VARIANCE APPEAL

DANE COUNTY BOARD OF ADJUSTMENT

RE: BOATHOUSE HEIGHT VARIANCE
PART OF LOT 7, ASSESSORS PLAT
OF FOX BLUFF, TOWN OF WESTPORT

VARIANCE FROM MAXIMUM HEIGHT OF BOATHOUSE

BOATHOUSE
ELEVATIONS

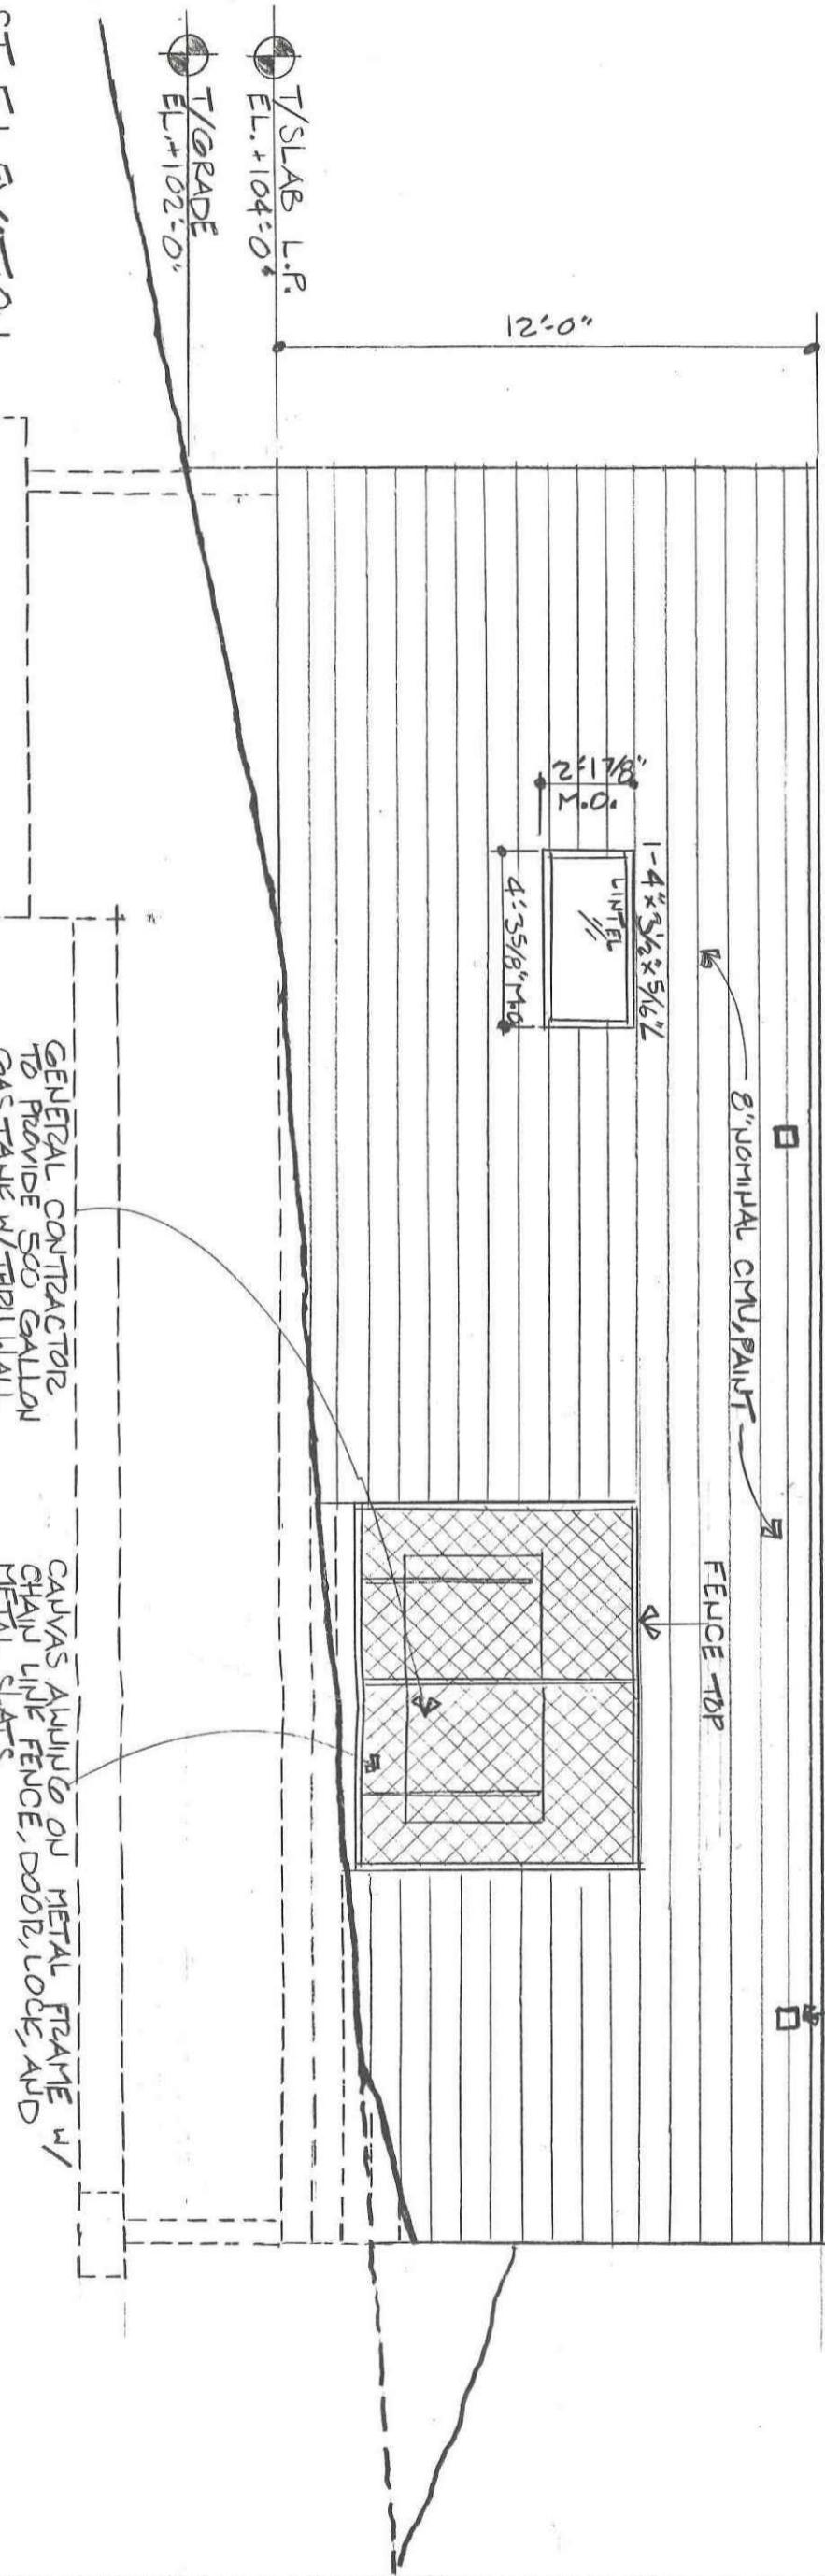
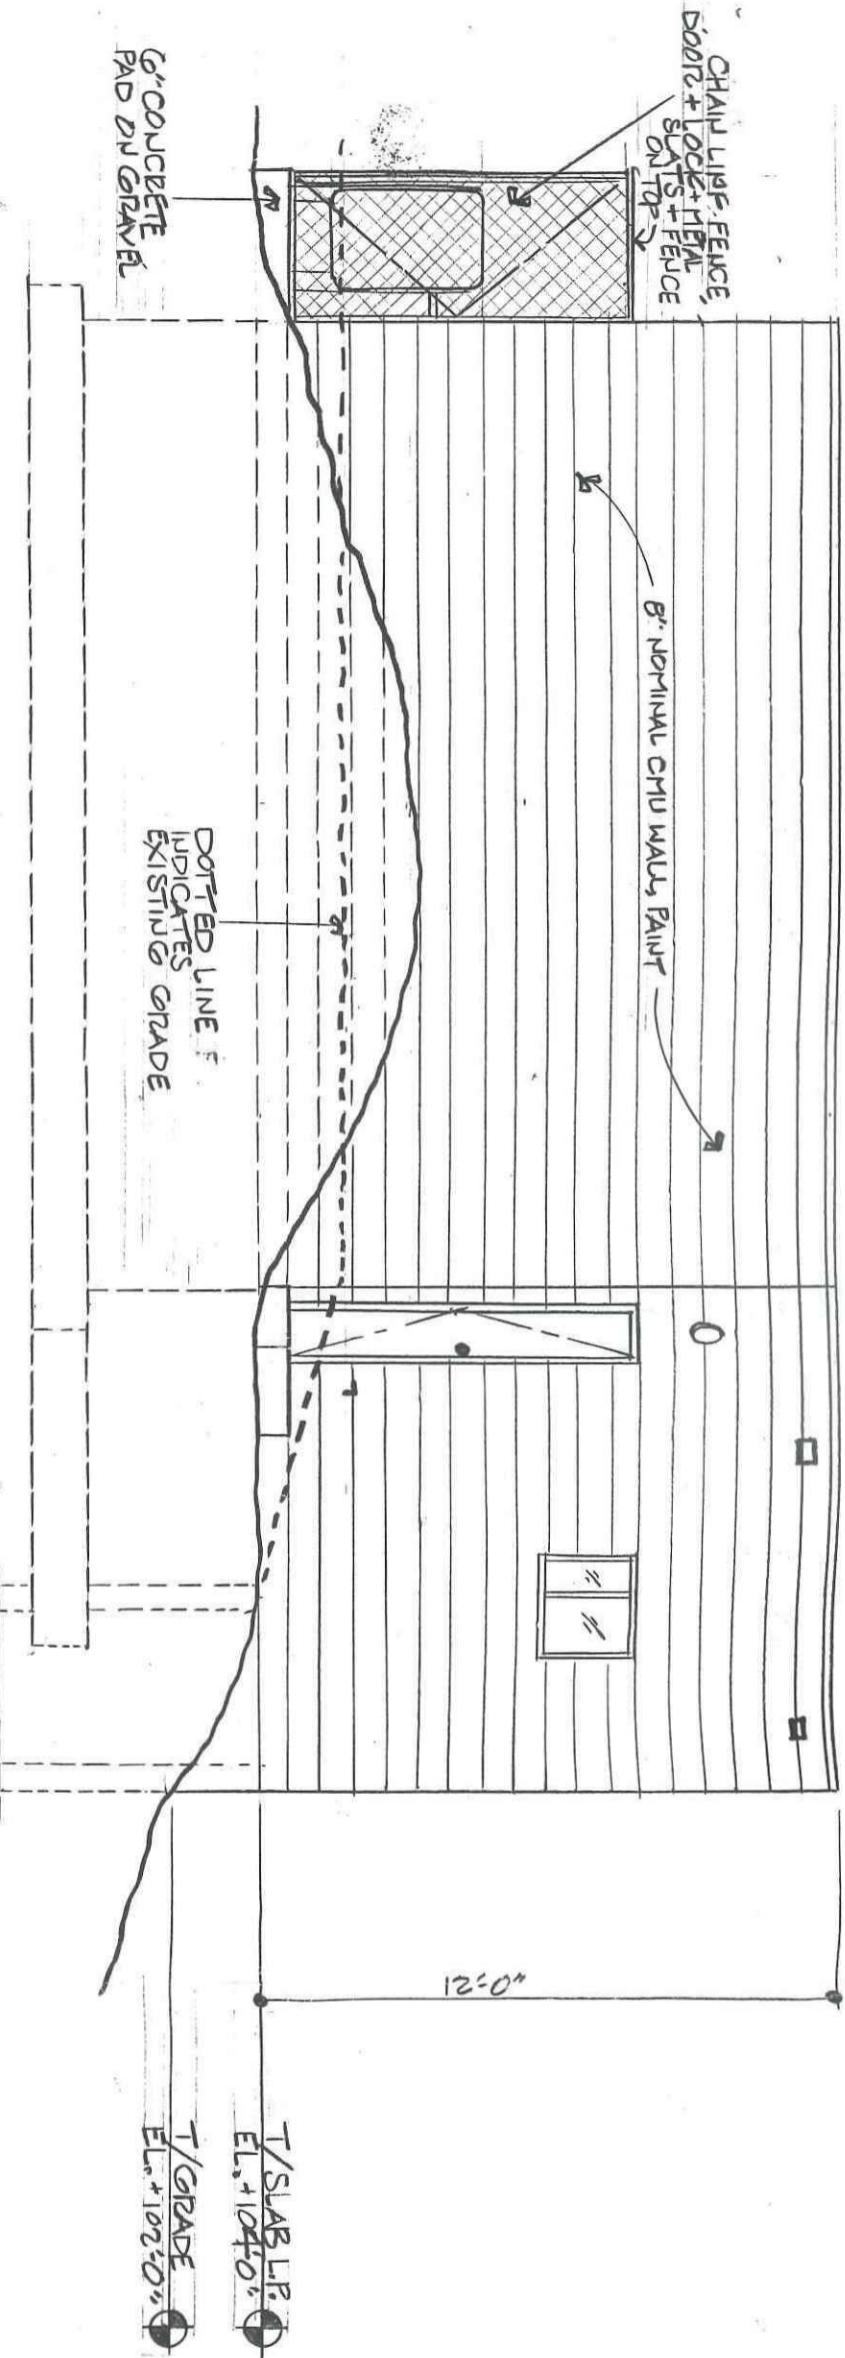
- X Place structure AT PROPER HEIGHT BY EXCAVATION OF BANK MATERIAL.
(location)
- X Reduce size of structure to PROPER HEIGHT.
(dimensions)
- Screen structure with _____ vegetation at least _____ ft. high.
(type)

EXCAVATION TO REQUIRED HEIGHT DOES NOT APPEAR TO BE A PROBLEM
AT THIS SITE. OTHER BOATHOUSES, OF GREATER HEIGHT, DO NOT
CONSTRAIN HANDSHIP ON THE PART OF THE APPRAISER.

P.H. 8/22/91: Grant with condition variance of 4 feet from maximum
height of boathouse above normal high watermark to permit construction

of new boathouse as proposed.

- 1). That atop boathouse there shall be no railing, no decking or no deck usage.
